SERVICE LETTER 184

8750 BAGGAGE FOAM REDUCTION

Aircraft Makes/Model(s):	Float Model(s):	Compliance: Optional	By: MAB
Cessna 208, 208B	8750A, 8750S	Part Number: 1009885	Approved: SDW
		Date: 6/3/2019	Revision: A

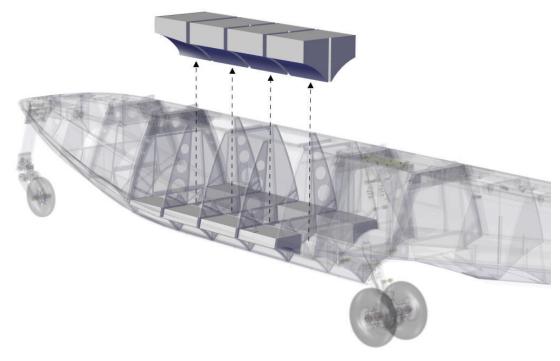
1. Open baggage compartments and remove AN screws and foam board baggage floor panels to gain access to the buoyancy foam

FIGURE 1 - MODIFIED BUOYANCY FOAM

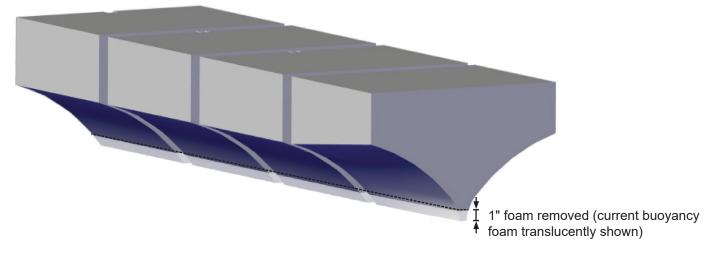
Some floats have been experiencing water compilation next to the buoyancy baggage foam inserts due to the baggage foam not allowing enough space in the baggage compartments for water to drain adequately

3. Remove 1 inch of foam from bottom of center buoyancy baggage foam inserts as shown below

Remove 1" of foam from the bottom of the center buoyancy baggage foam inserts to allow for more space for water disbursement
